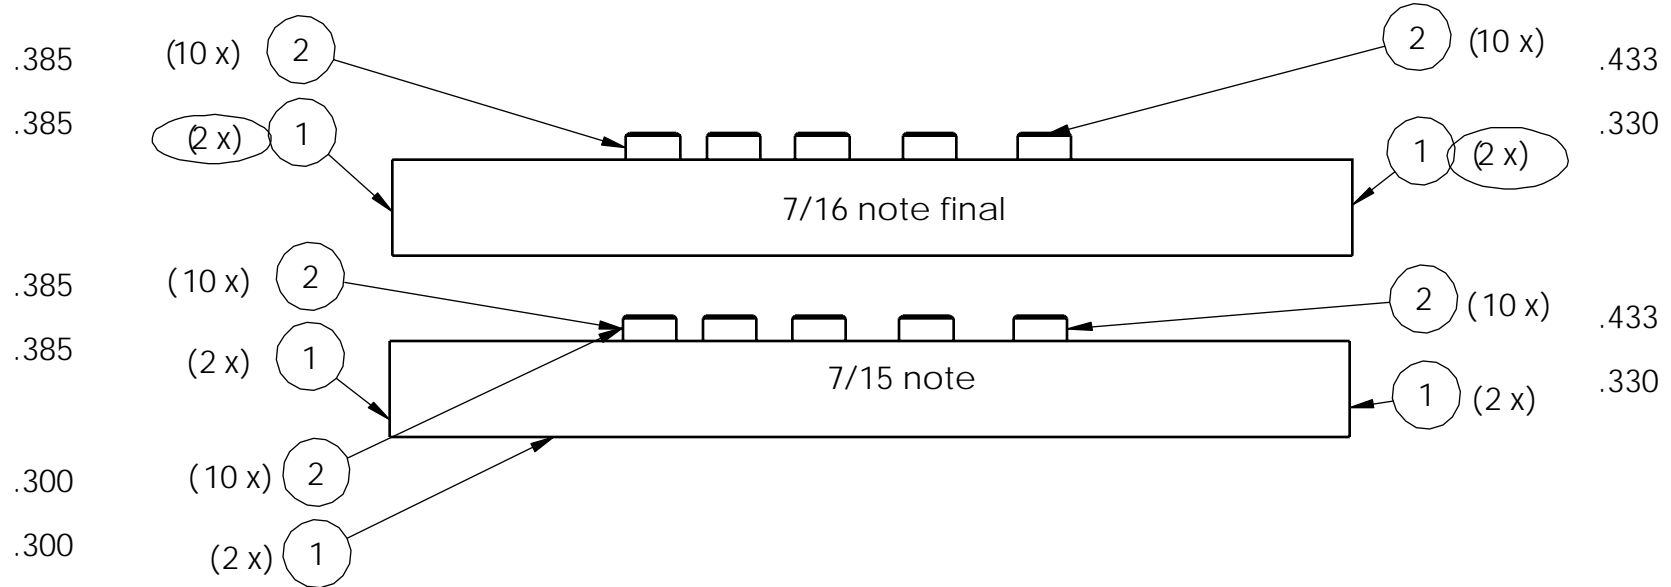
spacing could change
from .385 to .300 to be
more consistant with
other side
too close spacing between
(& number

good spacing between
balloon & (
too close spacing between
(& number

spacing could change
from .385 to .300 to be
more consistant with
other side

good spacing between
balloon & (
good spacing between
(& number
